ASHFORD ACRES SUBDIVISION, RESUBDIVISION OF **LOT 6**

APPLICATION NUMBER 18 DATE August 16, 2007

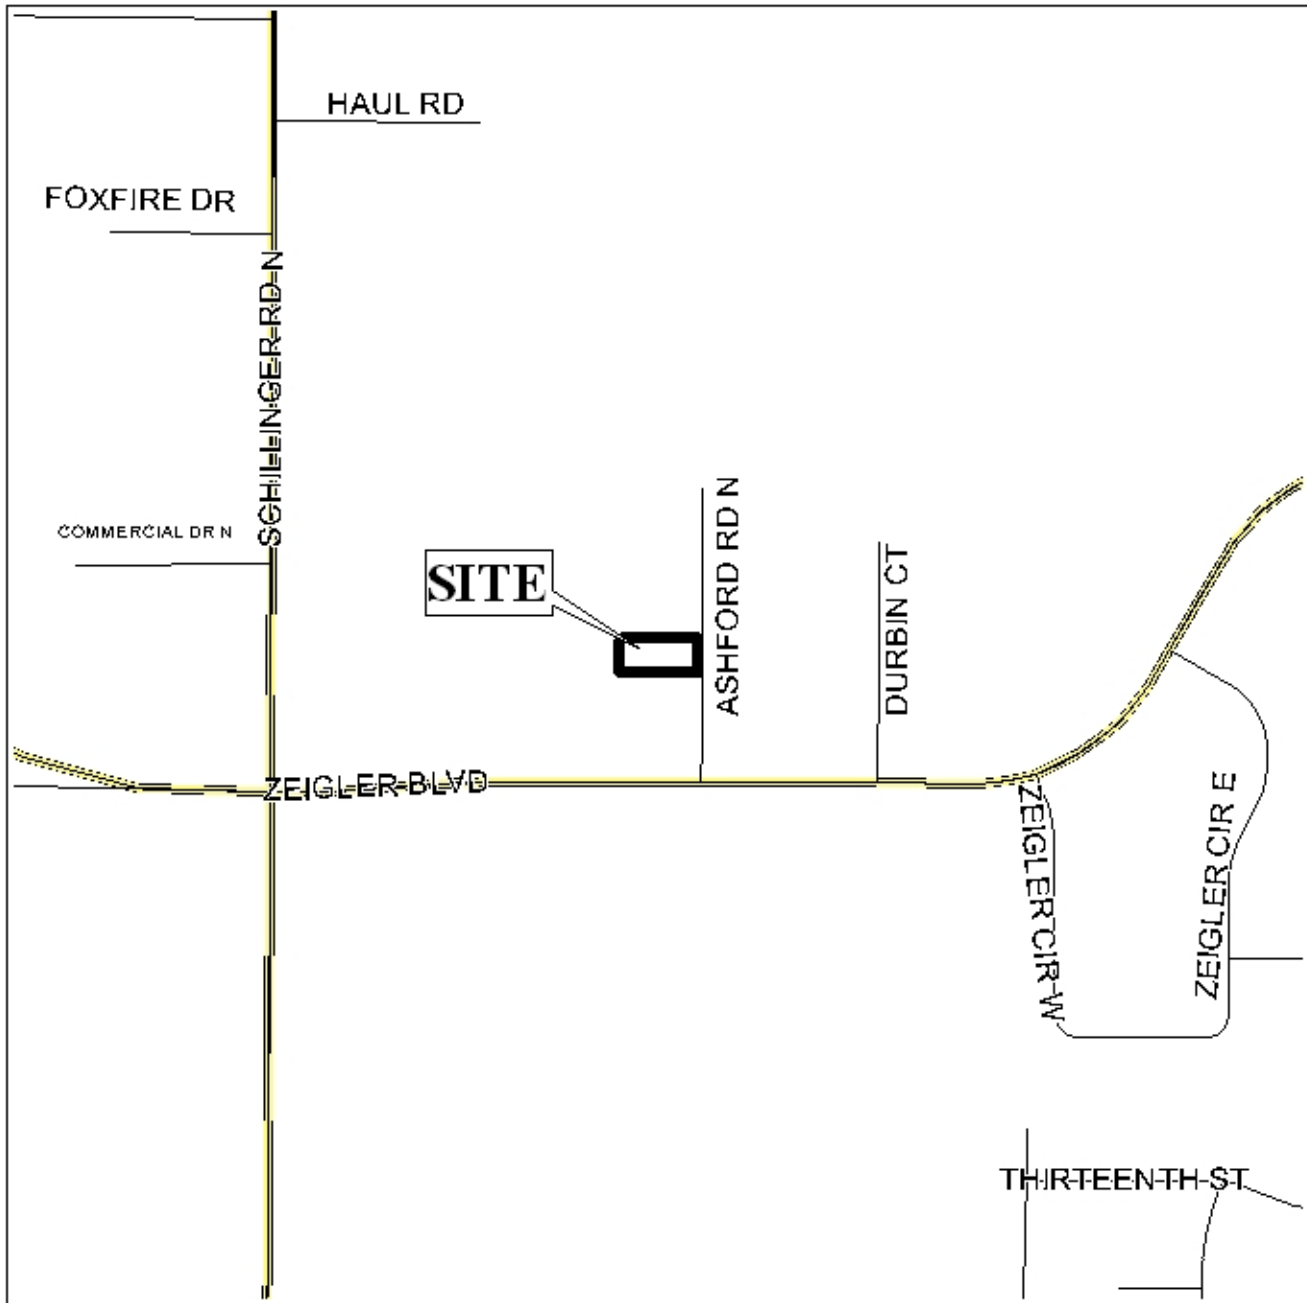
The site has frontage on Ashford Road North which has a 60' right-of-way. The plat does not depict a minimum building setback line along Ashford Road North; therefore, a minimum building setback of 25' along Ashford Road North should be depicted on the final plat, if approved. Also, a note should be placed on the final plat stating each lot is limited to one curb cut to Ashford Road North, with the size, location and design of all curb cuts to be approved by the Mobile County Engineering Department, if approved.

The lot sizes in square feet and acreage are indicated on the plat. The lot sizes in square feet, at a minimum, should also be depicted on the final plat, or a table provided furnishing the same information, if approved.

As proposed, the lots exceed the maximum width-to-depth ratio of Section V.D.3. of the Subdivision Regulations. As all eleven lots of Ashford Acres Subdivision remain in their originally-recorded size and configuration and meet the standards of Section V.D.3., resubdivision of this lot into long, narrow lots would be uncharacteristic of the subdivision and neighboring properties.

Based on the preceding, it is recommended that Section V.D.3. NOT be waived due to the uncharacteristic nature of the proposed lots with respect to other lots in the subdivision, and the plat be denied for the following reason:

- 1) the plat does not comply with Section V.D.3. of the Subdivision Regulations.
